The Commission has issued the enclosed Amendment Nos. 46, 46 and 43 for License Nos. DPR-38, DPR-47 and DPR-55, for the Oconee Nuclear Station, Unit Nos. 1, 2 and 3. These amendments consist of changes to the station's common Technical Specifications in response to your request dated July 5, 1977.

These amendments provide for the operation of Oconee Unit 3 Cycle 2 with the cycle length extended from 265 effective full power days (EFPD) to 282 EFPDs.

SUPPORTING AMENDMENT NOS. 46, 46 AND 43

OCONEE NUCLEAR STATION, UNIT NOS. 1, 2 AND 3

Figure 3.5.2-1C3

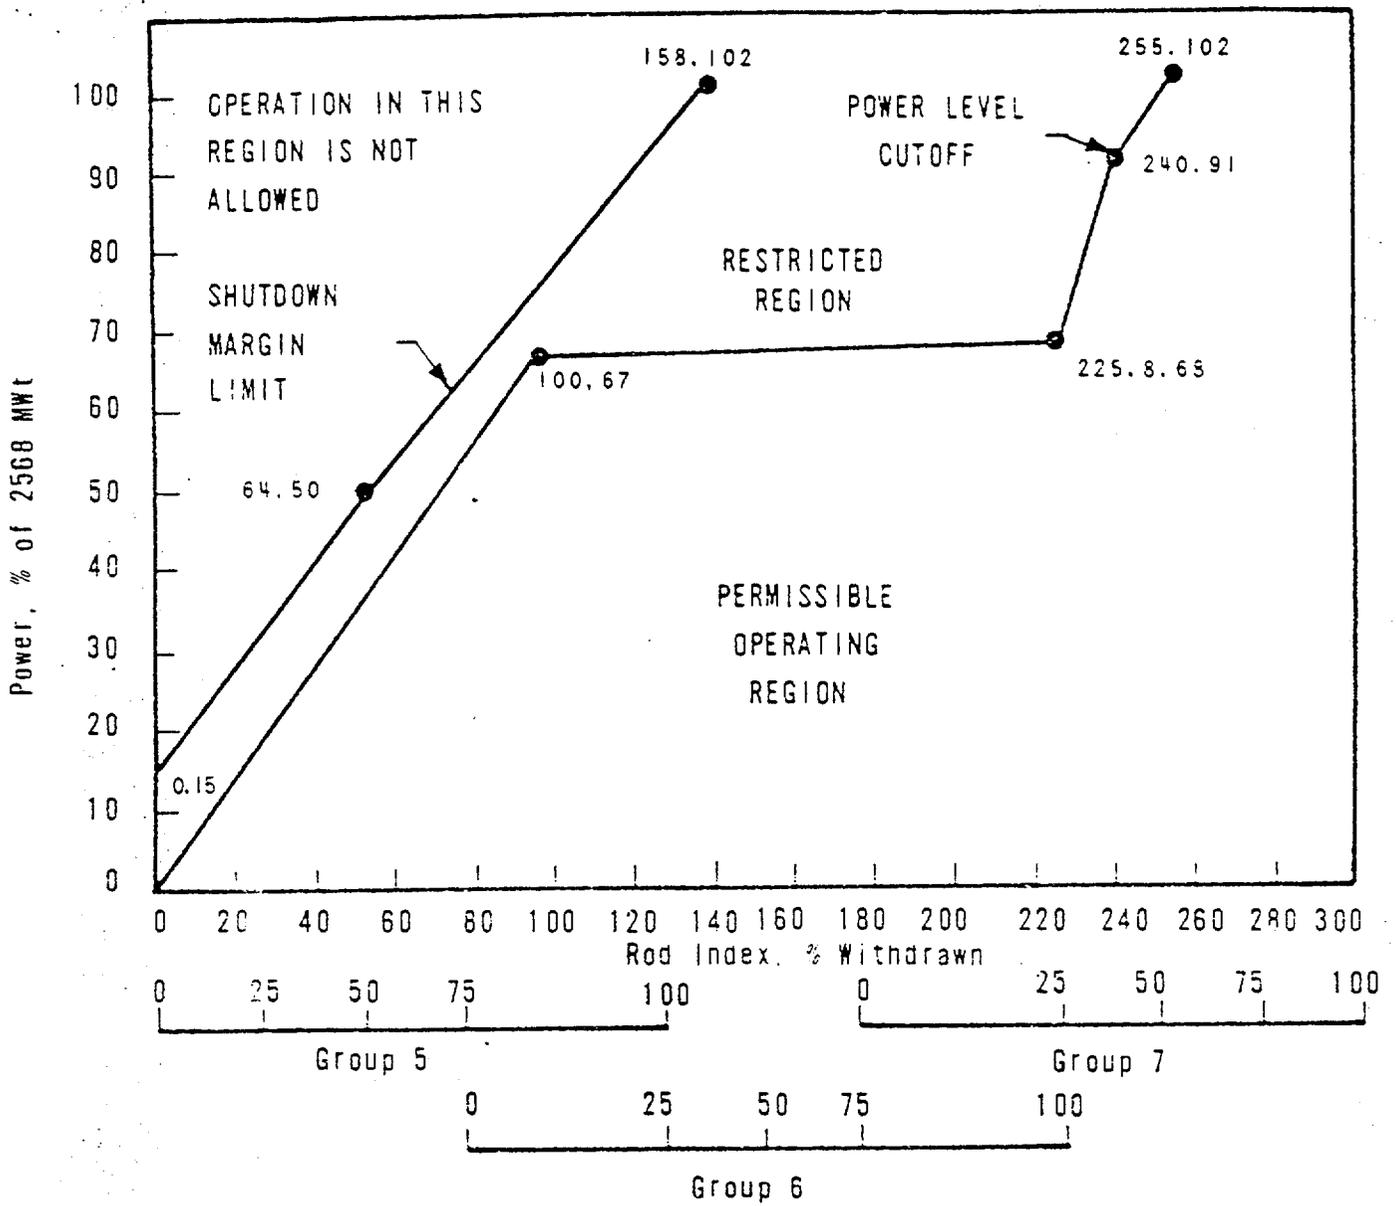
The licensee assessed the applicability of the existing Technical Specification limits for the extended Cycle 2 in a manner similar to that performed for the Cycle 2 reload. As a result of this assessment, it was determined that the operational control rod position limits (Technical Specification Figures 3.5.2-1C3 and 3.5.2-2C3) and the power imbalance limits (Technical

Specification Figure 3.5.2-3C3) would require slight modifications to account for limiting conditions which would exist in the extended part of the cycle.

ROD POSITION LIMITS FOR FOUR-PUMP OPERATION AFTER 226(±10) EFPD Unit 3
